Town of Surfside

RFQ 2022-05

Construction of Town of Surfside 96th Street Park

Addendum No. 4

Vitriturf System

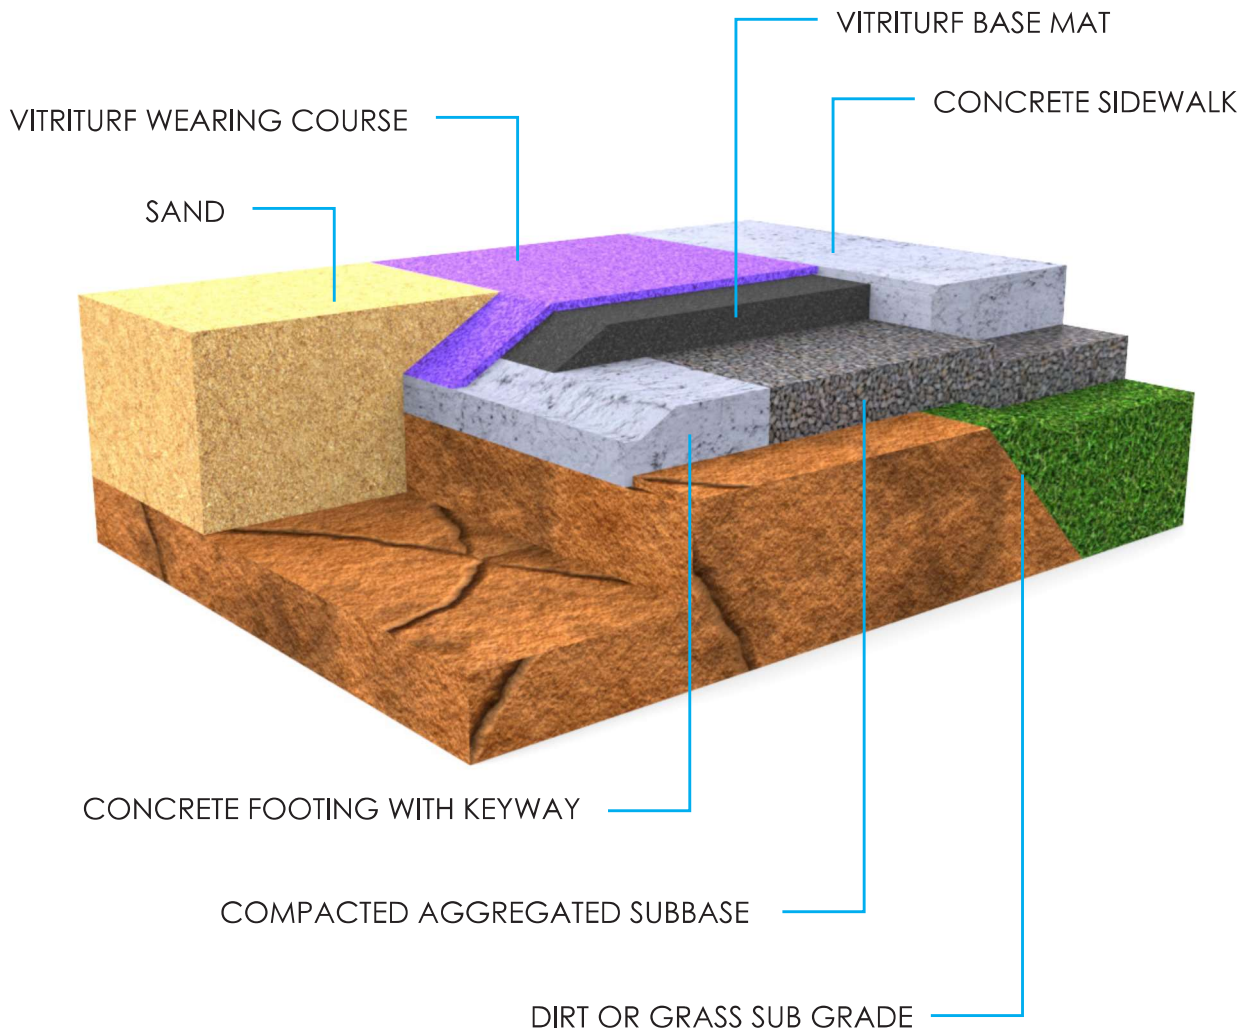
27. Please see attached Vitriturf System Curb Loosefill and Curb Detail provided by Playmore Recreational Products & Services (Local Vendor for Berliner Playground Equipment). Please compare to Detail #3 on Sheet LH-02 and confirm this is an acceptable assembly for the Sub-base System for the Poured in Place Rubberized Safety Surface at the Playground.

Yes, attached detail provided by Playmore is acceptable.
